ANN ARBOR HISTORIC DISTRICT COMMISSION

Staff Report

ADDRESS: 1003 West Liberty Street, Application Number HDC19-211

DISTRICT: Old West Side Historic District

PROPOSED FLOOR PLAN

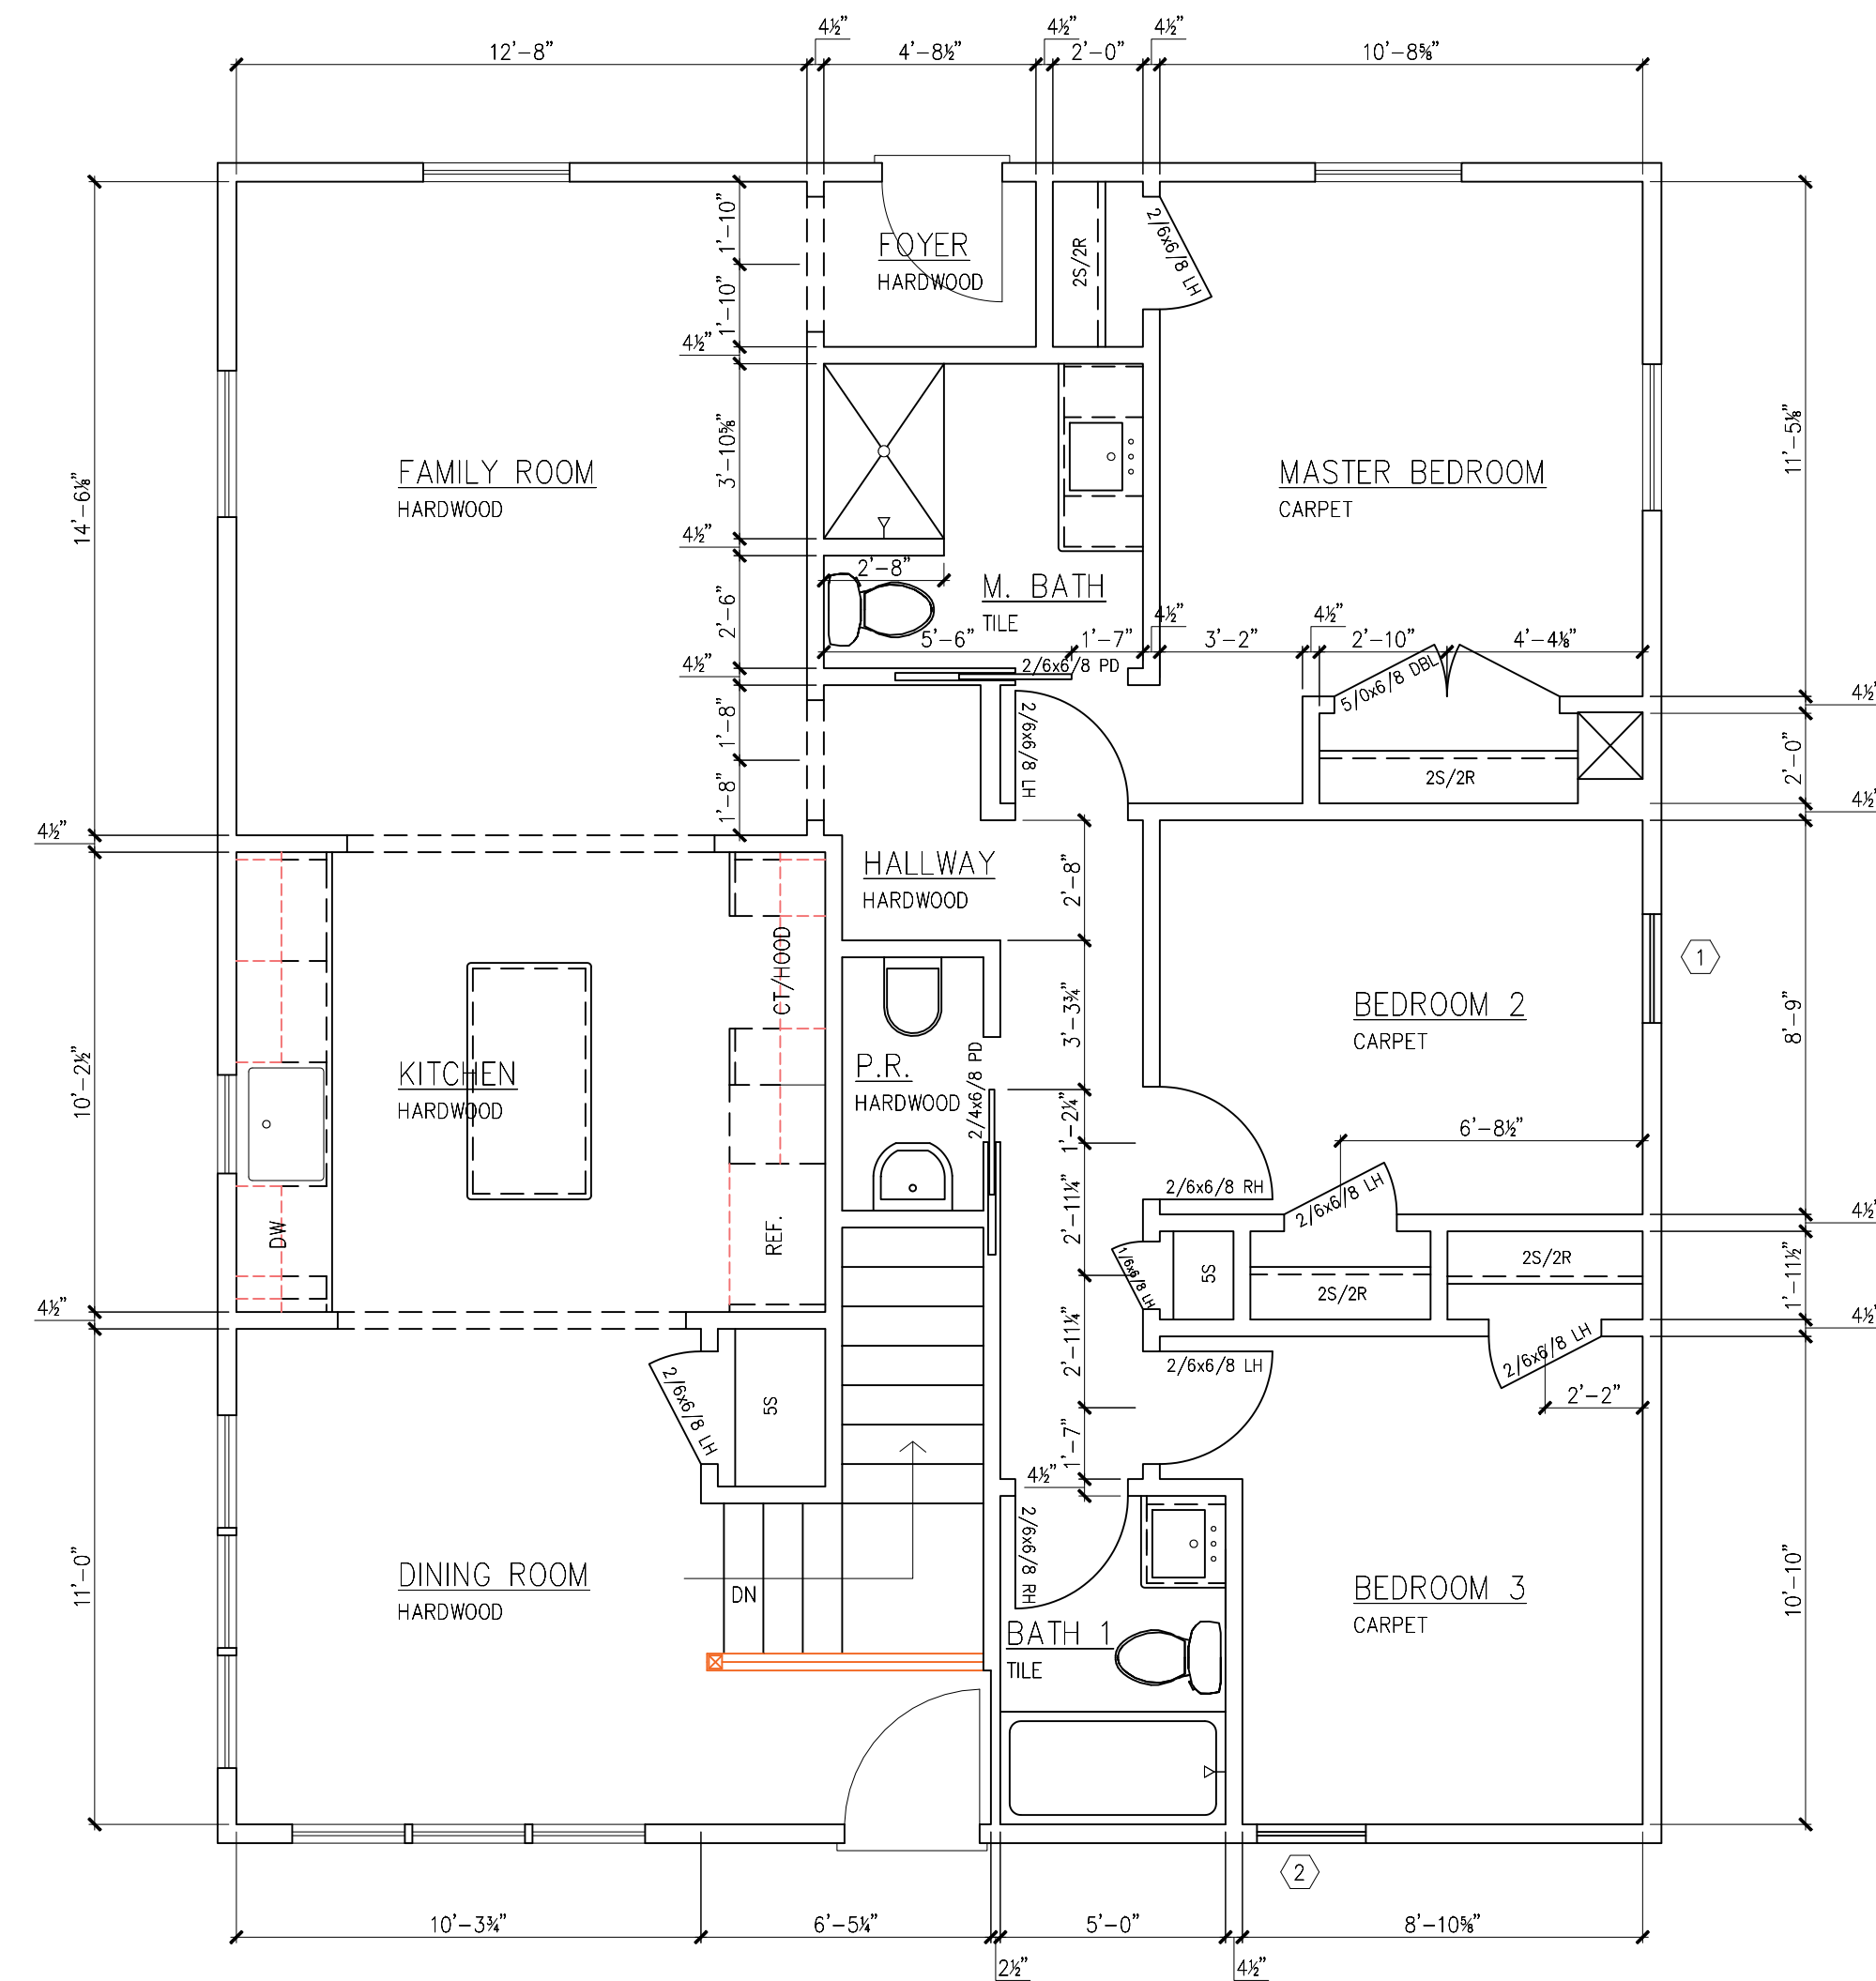
1. The owners purchased this house in the spring. The house is a single-story, with one double-sized master bedroom and a second interior bedroom with no windows. The floorplan is fairly illogical due to a rear addition (date unknown, but does not appear on the 1947 aerial photo) that added a sunroom and expanded the master bedroom. They propose to rearrange the interior to make three usable bedrooms, but touching these rooms triggers the requirement for egress windows. One is on the east side elevation near the center of the wall, and the other is on the south rear elevation. Both have a six-over-one muntin pattern. The contractor confirmed that the clear opening size does not meet the 5.0 square feet required by code for first-floor egress.

2. Though the windows are the same size, the one in the rear is either a modern (post-1947) window, or if it appears to be the same age as the one on the side, could have been re-used when displaced by the addition.

3. Staff agrees that the proposed floorplan is a reasonable use of space in this compact house. The alternative to this proposal would be to add two new windows, which staff feels would be more disruptive to the simple design of this house. The replacement windows have appropriate applied muntins and center rails, both with interior spacers, which are less visually disruptive than a single-lite casement would be.
